CONSTRUCTION DOCUMENTS  
 FALCON MEADOWS AT BENT GRASS FILING NO. 4  
 FOR  
 CHALLENGER COMMUNITIES, LLC  
 BENT GRASS MEADOWS DRIVE & MERIDIAN ROAD  
 FALCON, CO 80831 - EL PASO COUNTY

### LEMON GRASS RD IMPROVEMENT PLAN

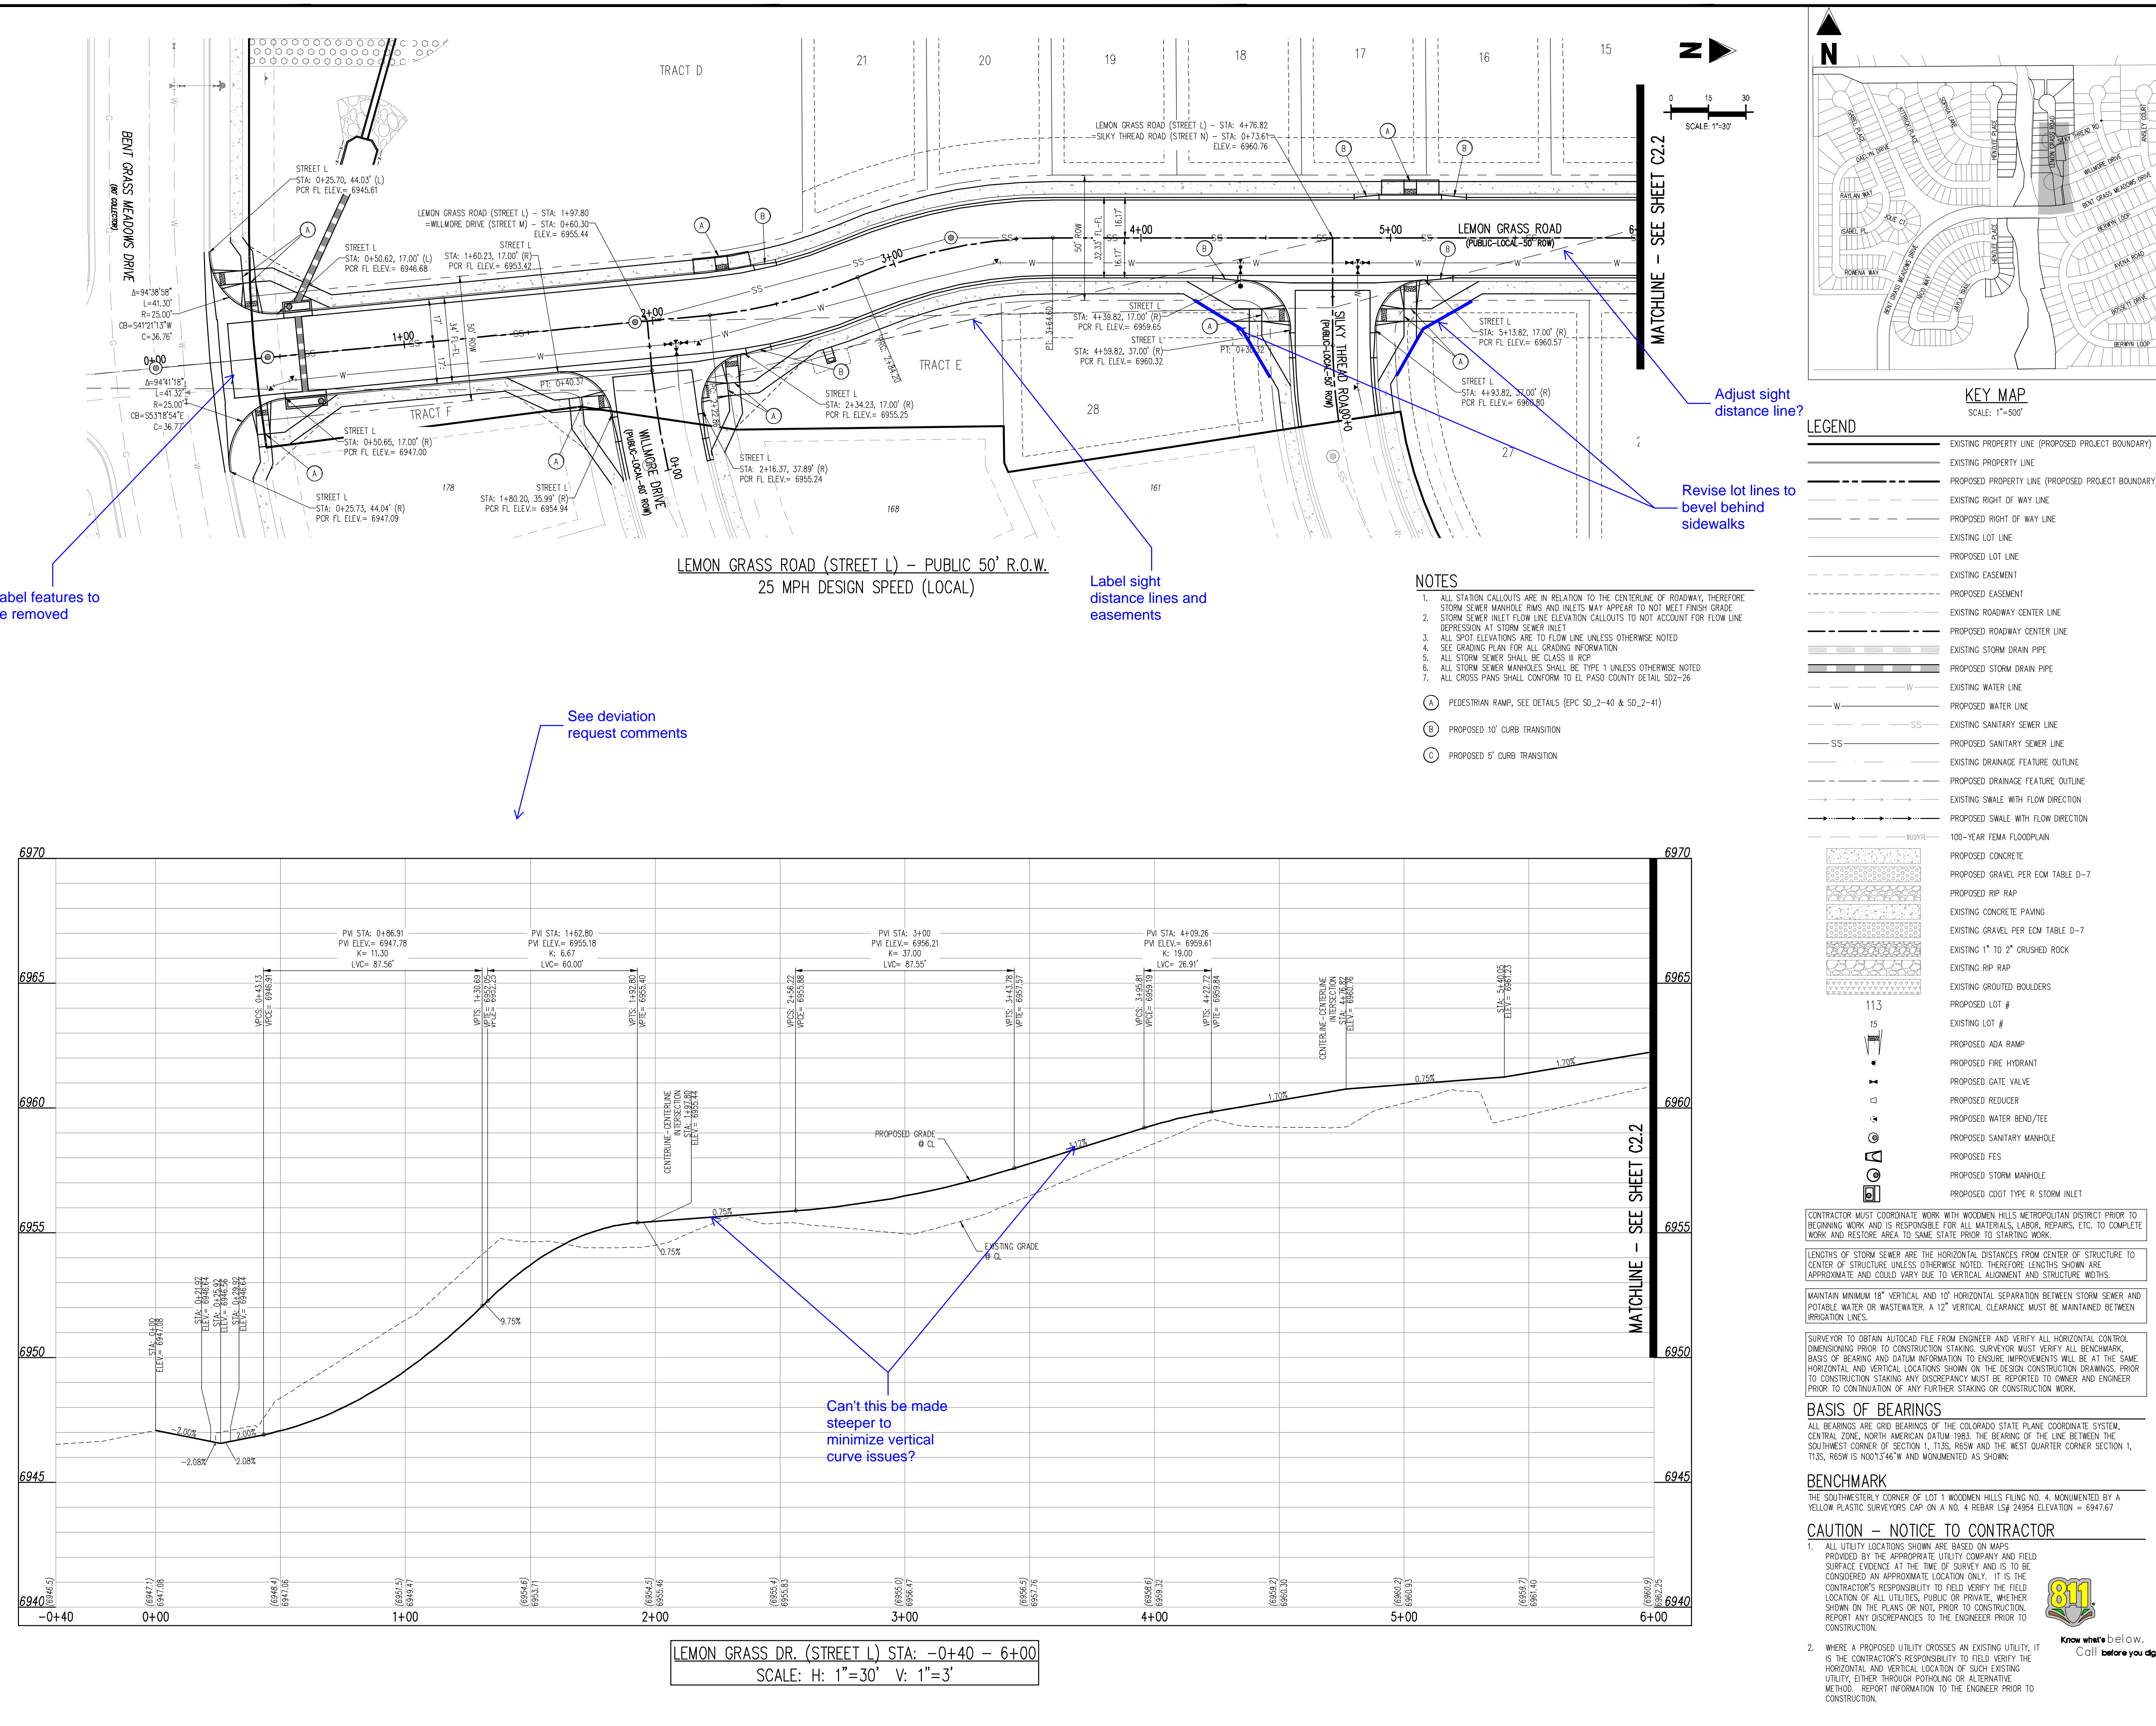
Label features to be removed

Adjust sight distance line?

Revise lot lines to bevel behind sidewalks

Label sight distance lines and easements

LEMON GRASS DR. (STREET L) STA: -0+40 - 6+00  
SCALE: H: 1"=30' V: 1"=3'

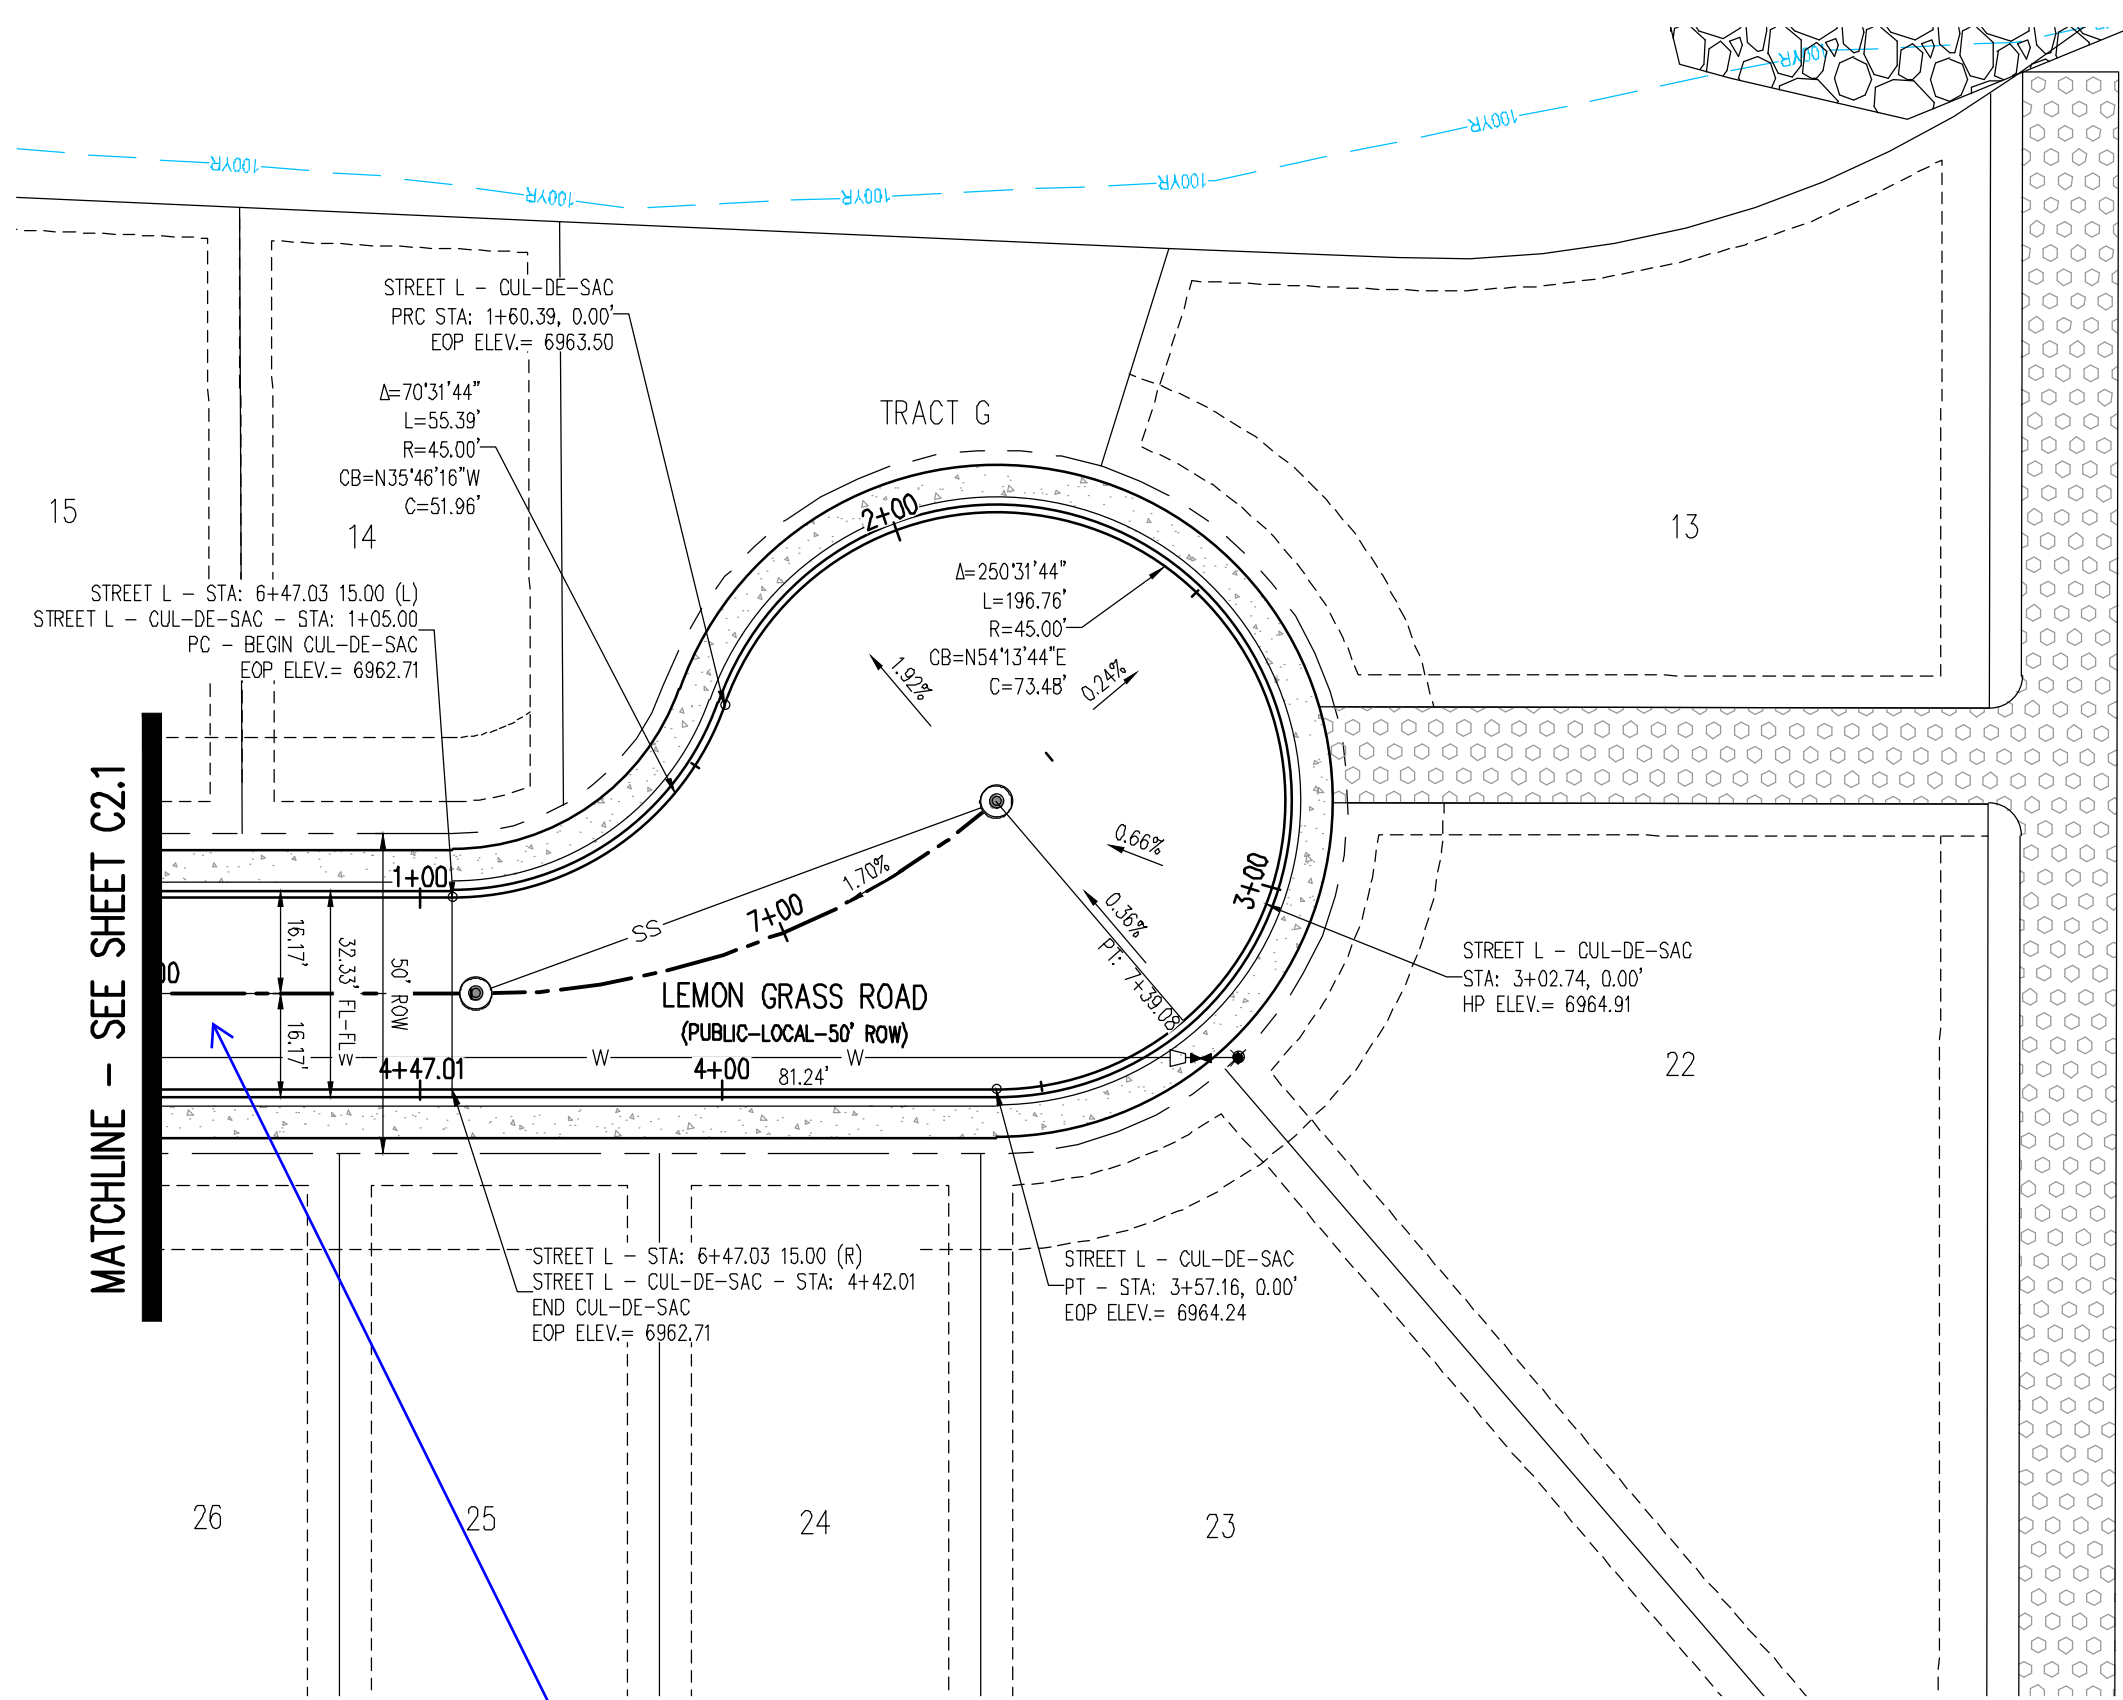
See deviation request comments

Can't this be made steeper to minimize vertical curve issues?
